STATE OF HAWAII	
DEPARTMENT OF TRANSPORTATION	
HIGHWAYS DIVISION	
PLAN & PROFILE - GENERAL NOTES	
INTERSTATE ROUTE H-1	
WAI'AWA INTERCHANGE	
F.A.I. Proj. No. I-HI-1(46):8	
(PAVING OF H-2 CONNECTION)	
Scale: As shown	
SHEET No.	OF SHEETS

SUPPLEMENT
INB. @ STA. 449+50 to 457+76.47
WAIAWA INTERCHANGE
F.A.I. Proj. No. I-HI-1(46)-8

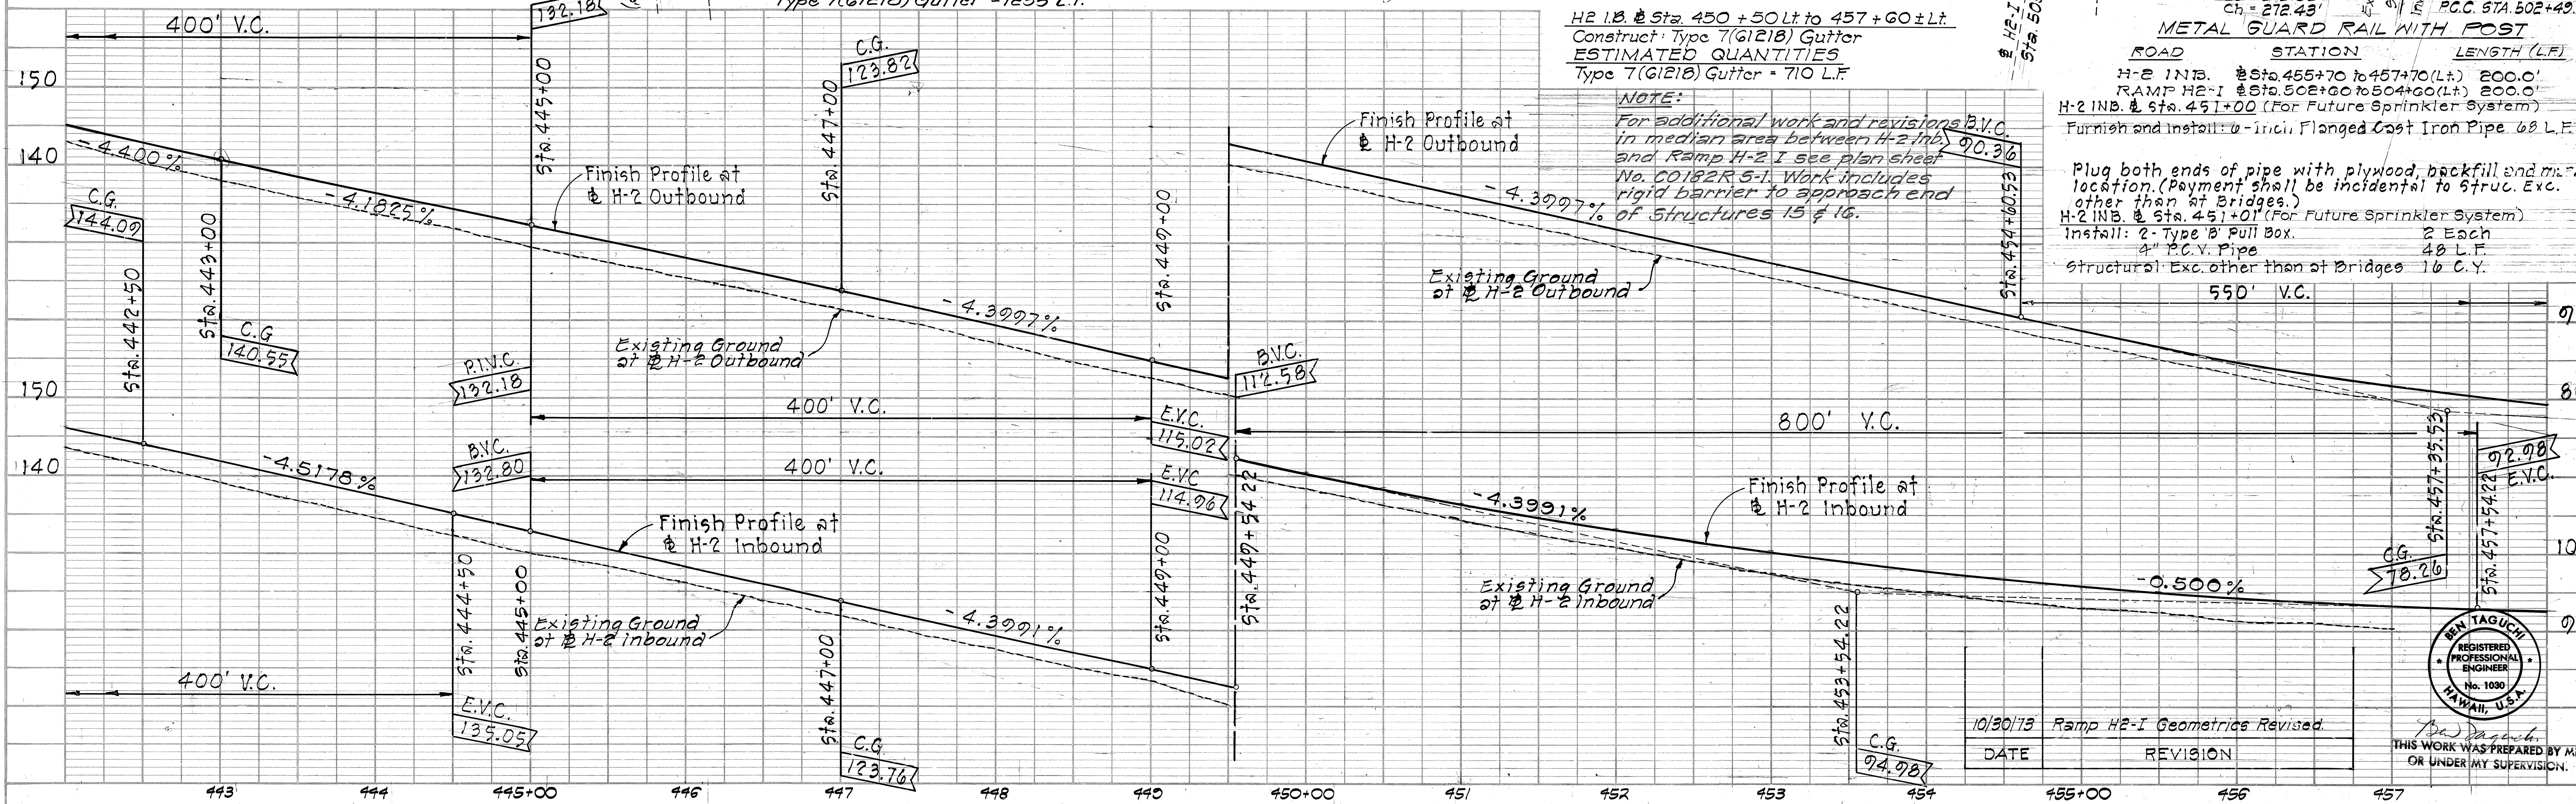
NOTE:
For additional work and revisions to V.C. in median area between H-2 INB and Ramp H-2 I see plan sheet No. C0182R 5-1. Work includes rigid barrier to approach end of Structures 15 & 16.

10/30/73 Ramp H2-I Geometrics Revised
DATE REVISION

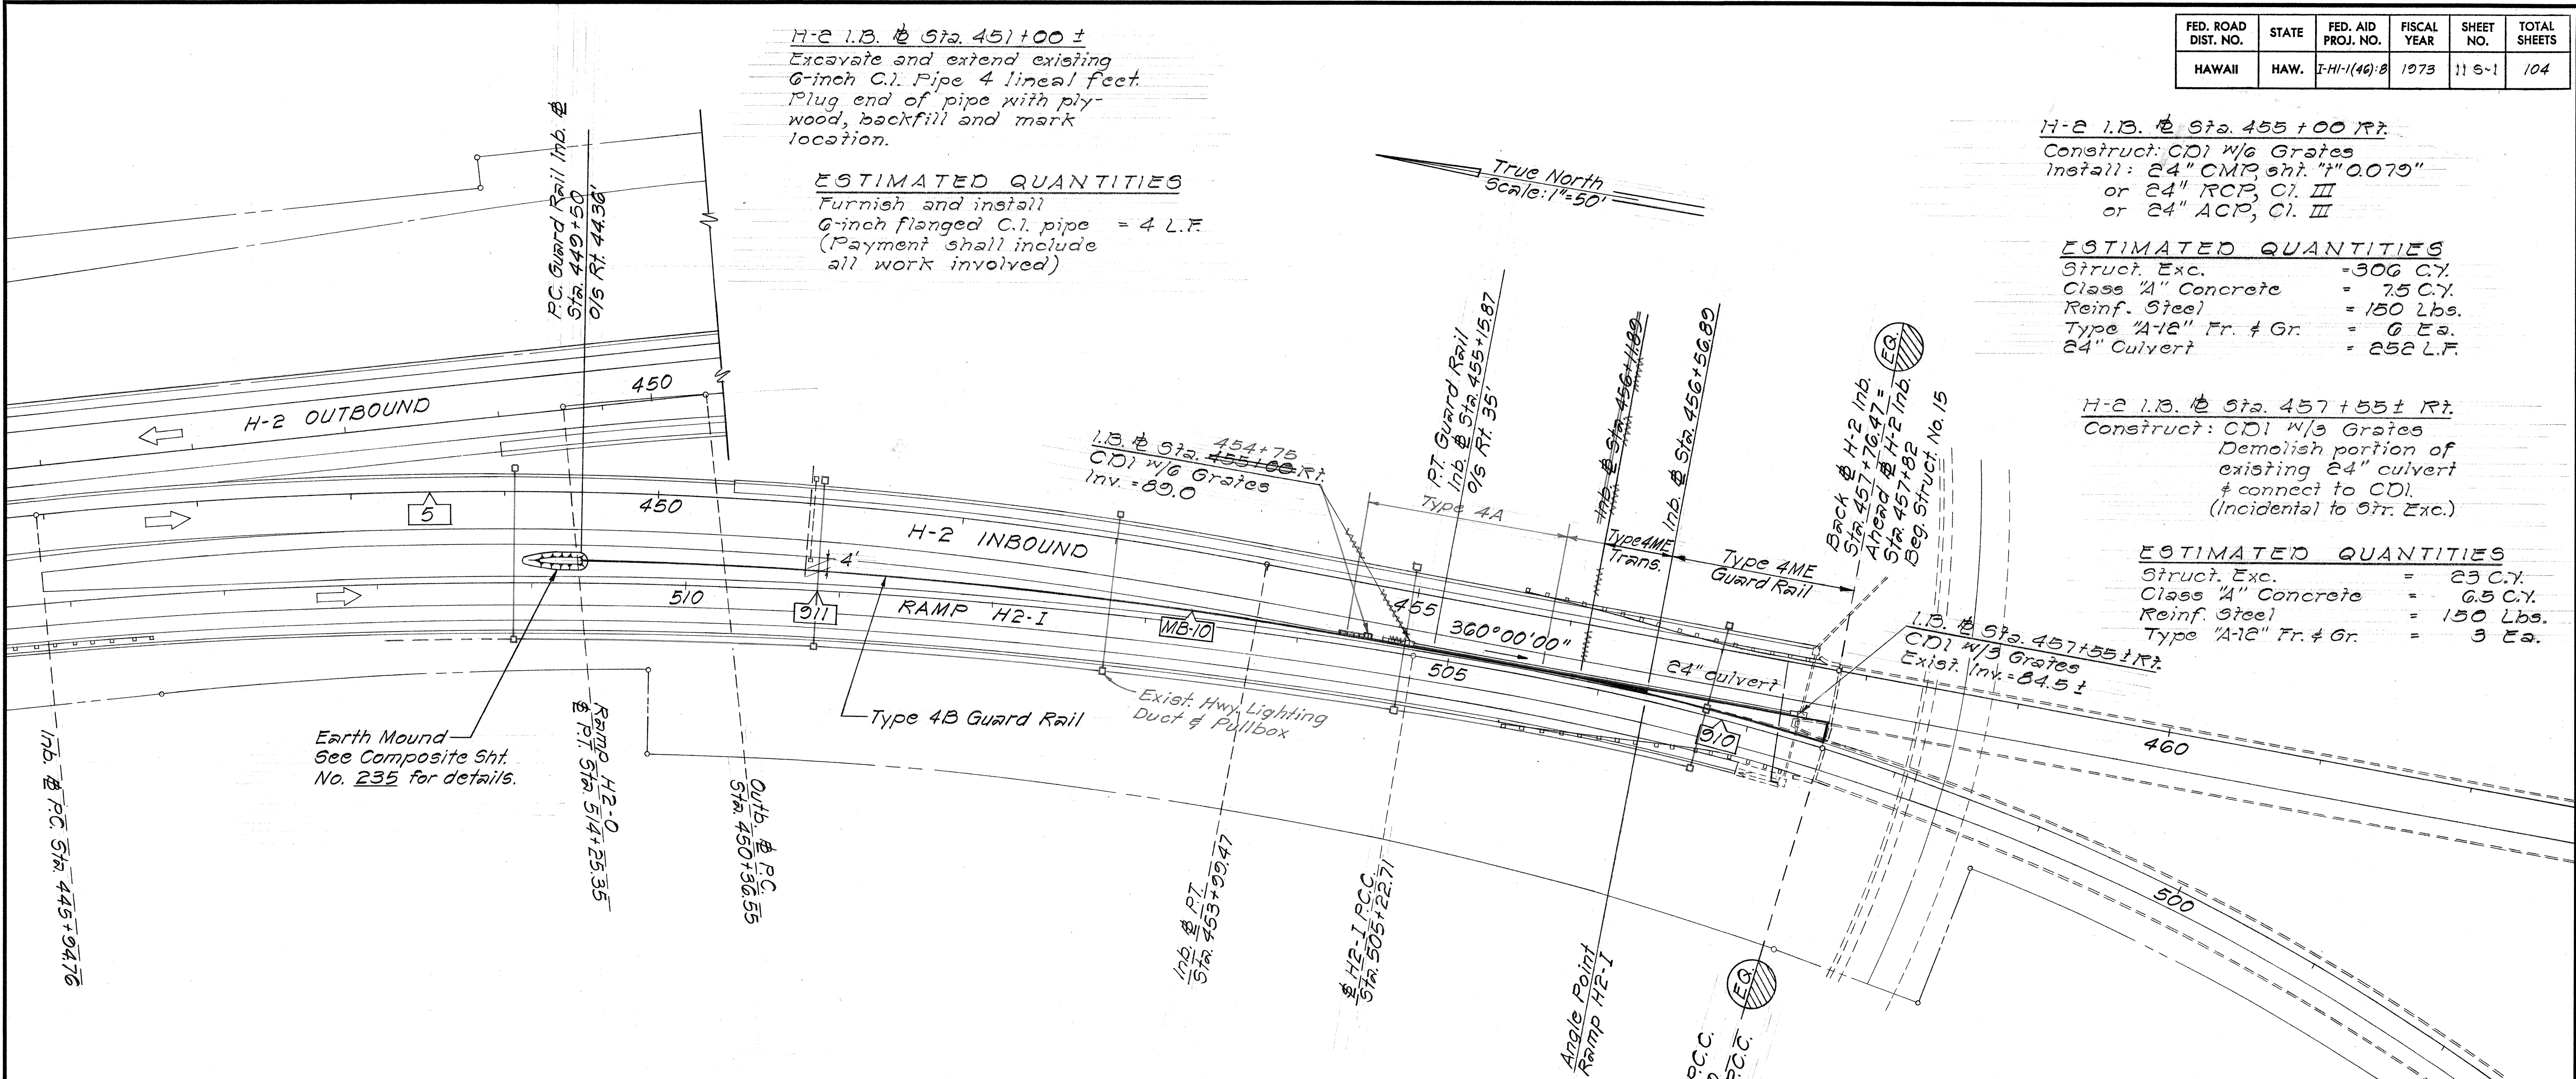
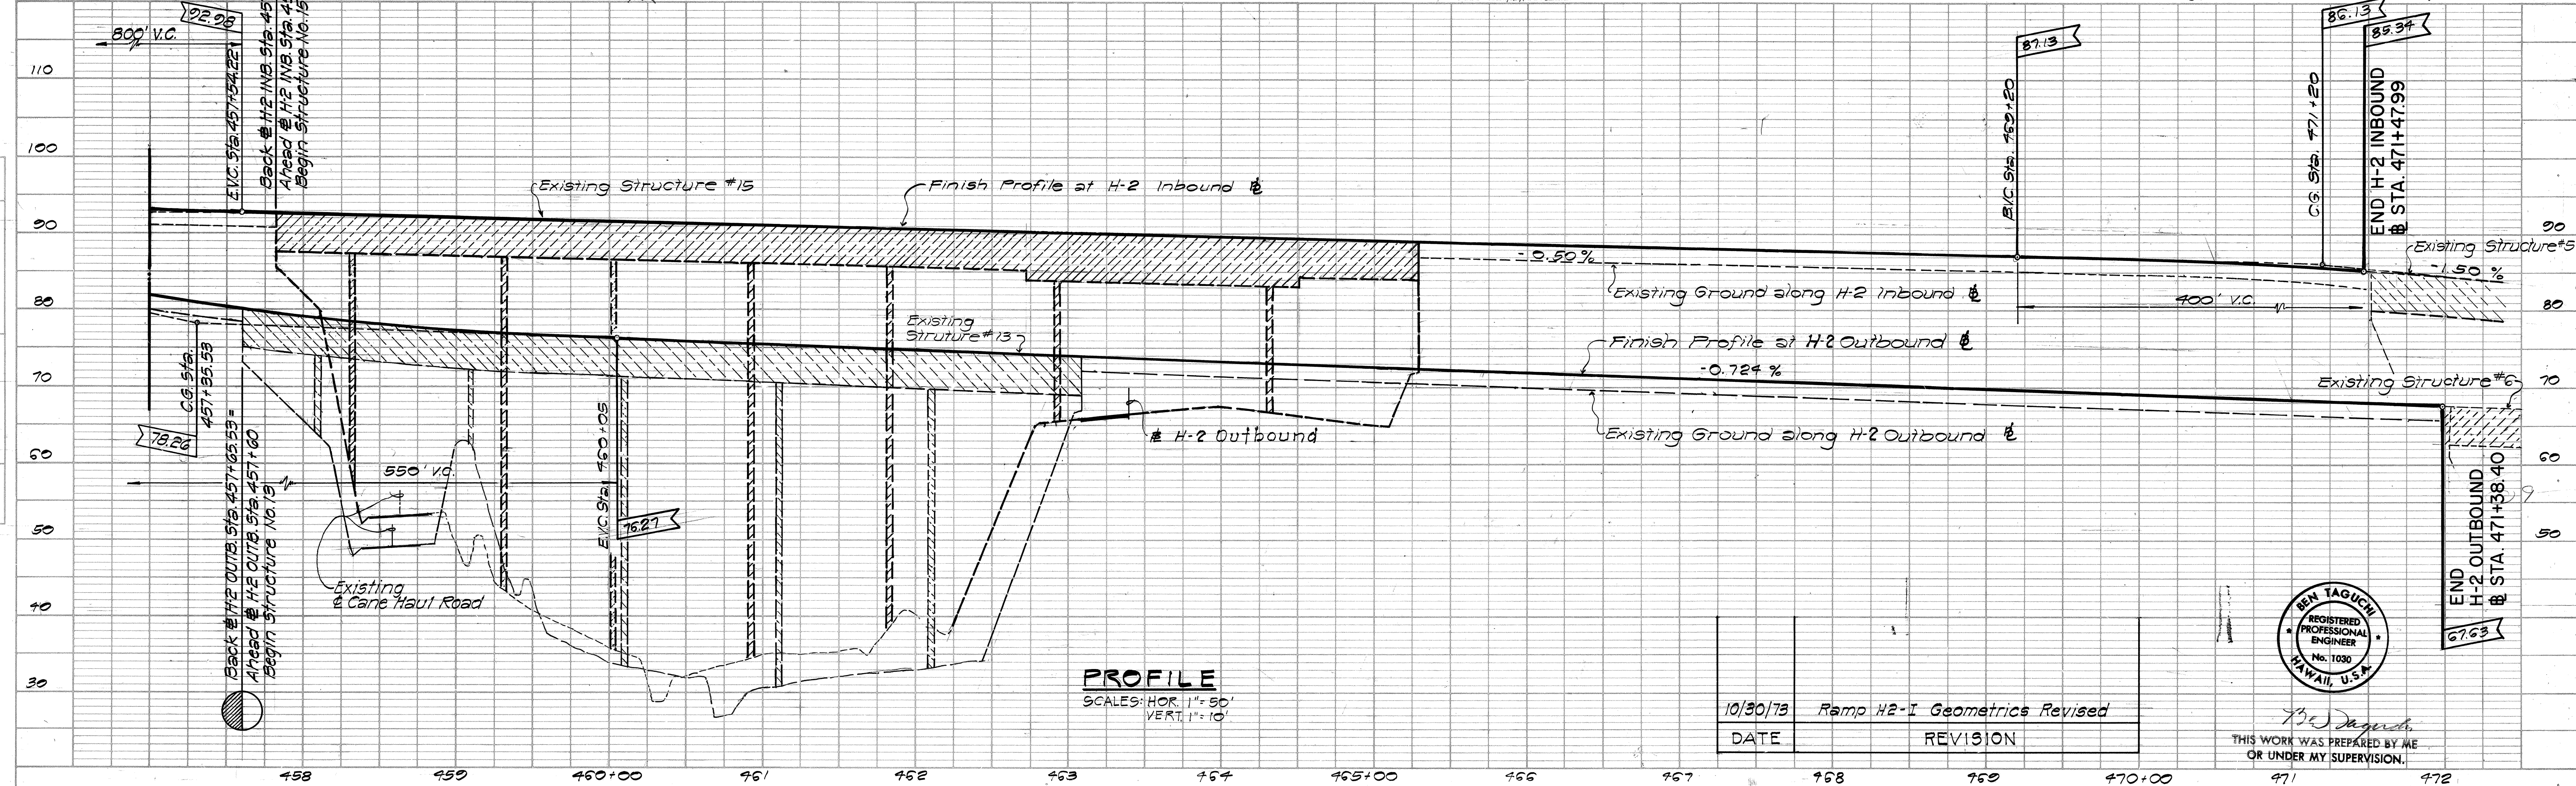
- NOTES:**
- Type 4B Guard Rail will be paid for under Item No. 606.411. Earth Mound at Inb. @ Sta. 449+50 will be considered incidental to new Item No. 606.415, Guard Rail-Type 4ME.

- Type 4ME Guard Rail (See Composite Sht. No. C.O. 246 S-1 for details)
 - Payment for Type 4ME will be paid for per Linear Foot, measured along the front face of H2-Inb., under new Item No. 606.415 - Guard Rail, Type 4ME, and will include full compensation for furnishing all labor, materials, tools, and equipment and incidentals necessary to complete the work.

- Compacted earth fill, 4" concrete slab, reinforcing steel, curtain wall, will not be paid for separately but will be considered incidental to Type 4ME Guard Rail.

- Type 4ME Transition will be paid for per Linear Foot under new Item No. 606.415 - Guard Rail, Type 4ME.
 - Type 4ME and Transition controlled by edge of shoulder, see Composite Sht. No. C.O. 236 S-1 for details.

PLAN
RAMP H2-0
 SCALE: 1"=50'

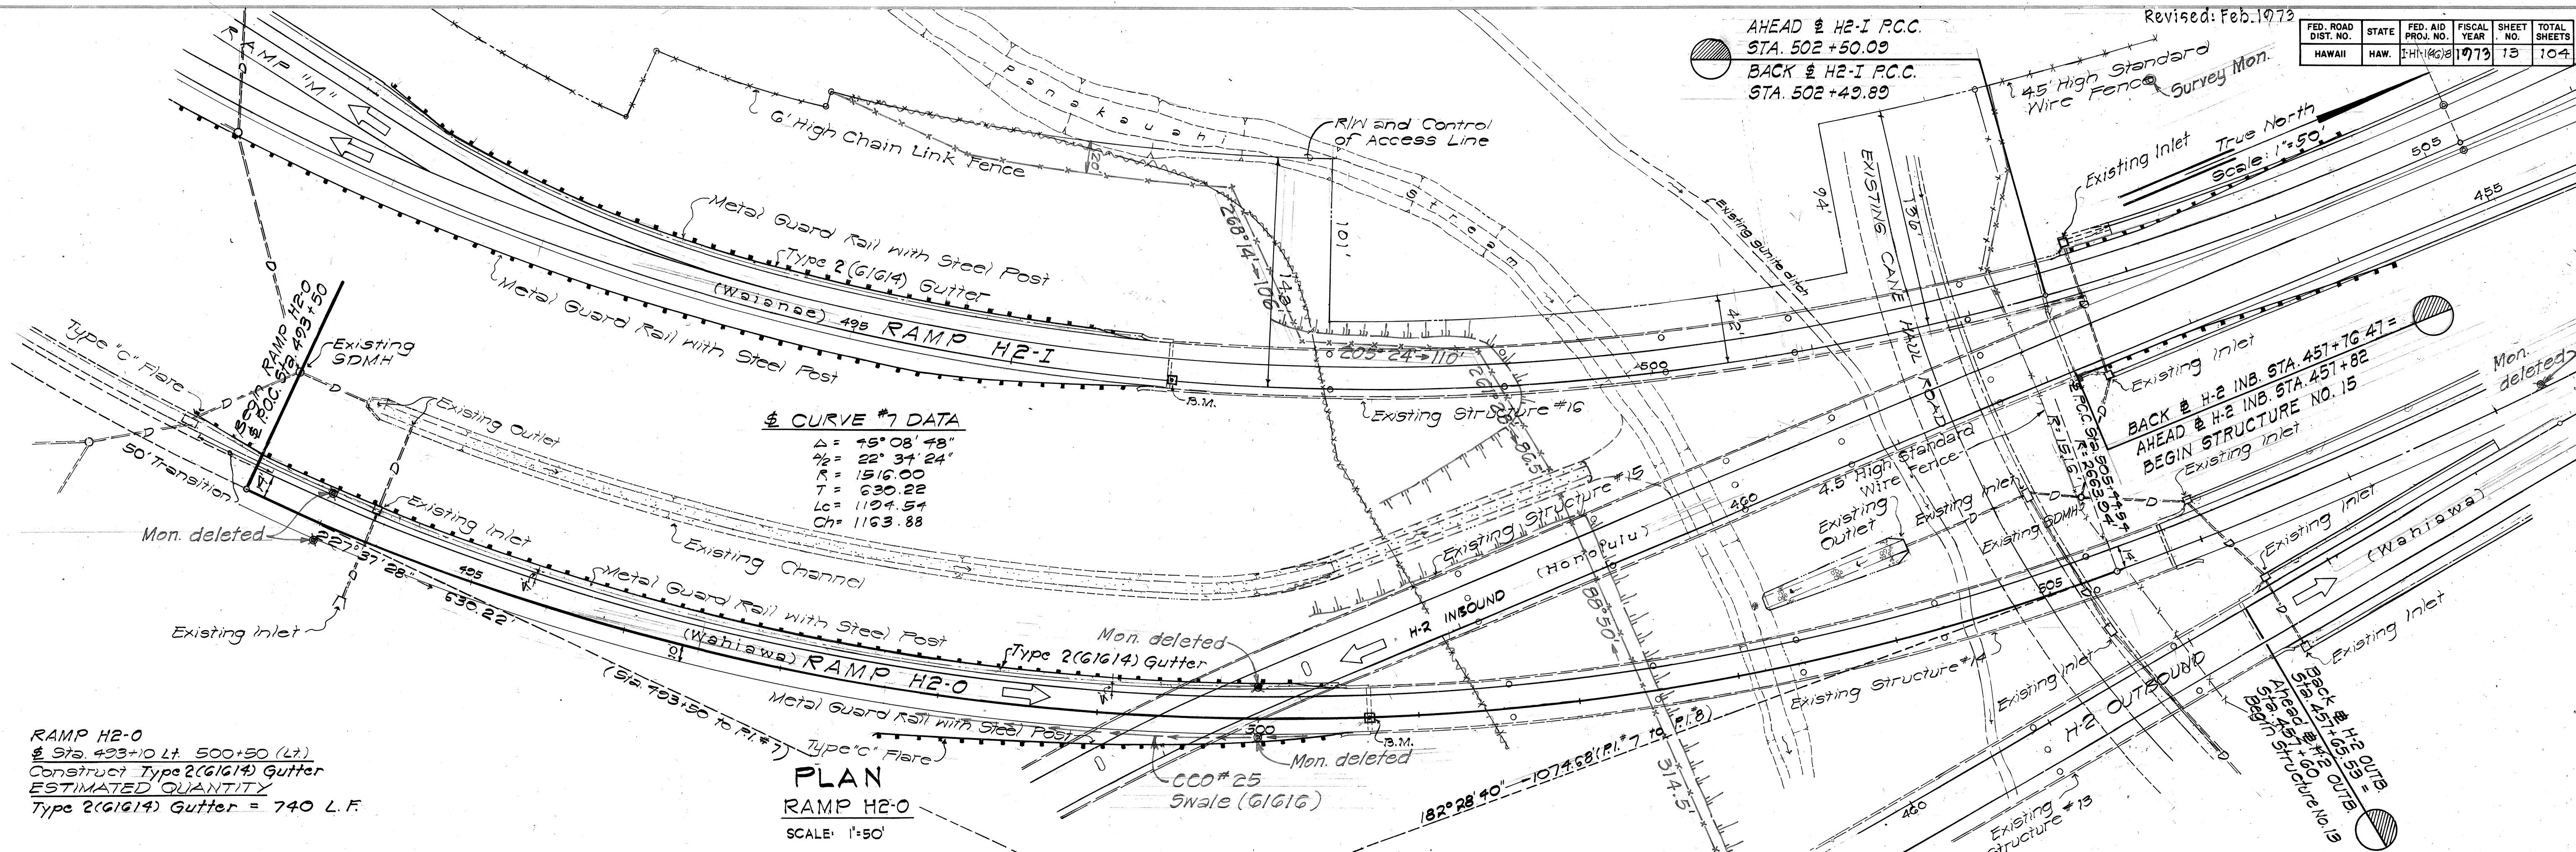
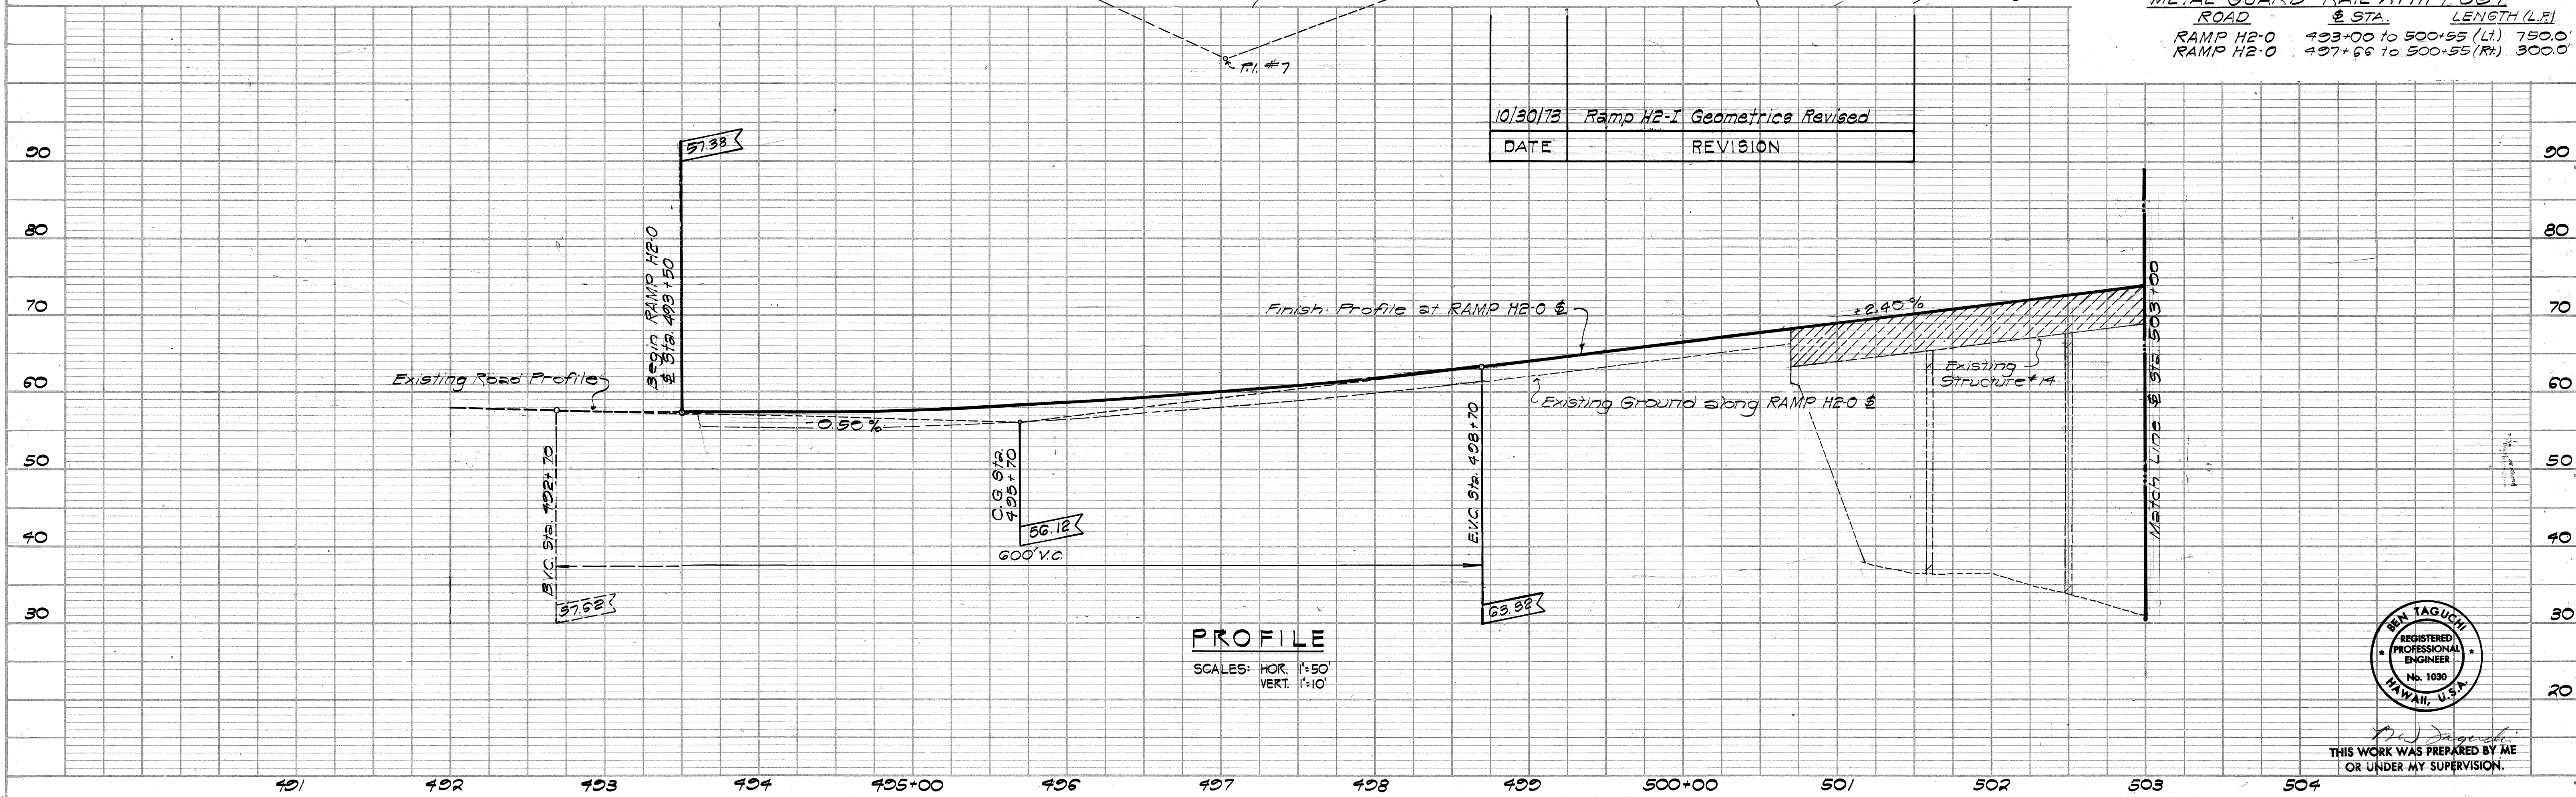
10/30/73	Ramp H2-I Geometrics Revised
DATE	REVISION
